ATTACHMENT 3

PROPOSED TECHNICAL SPECIFICATIONS

Marked Up Technical Specification Pages:

FIGURE 2.1-1

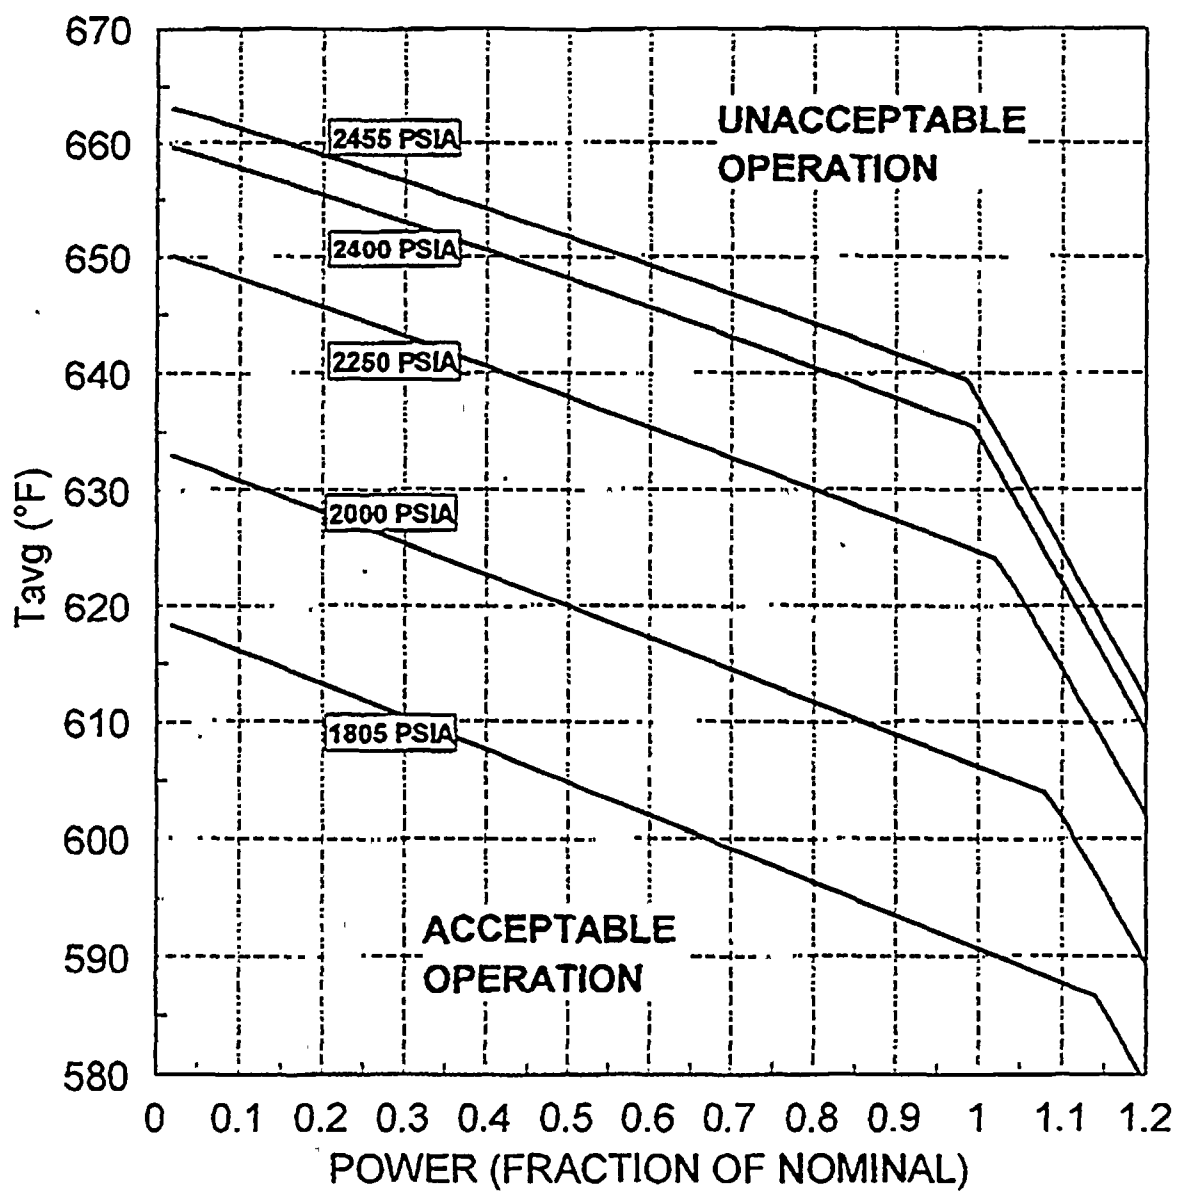
SUBSTITUTE THE  
ATTACHED FIGURE  
FOR THIS FIGURE

**Figure 2.1-1**  
**Reactor Core Safety Limit -Three Loops in Operation**
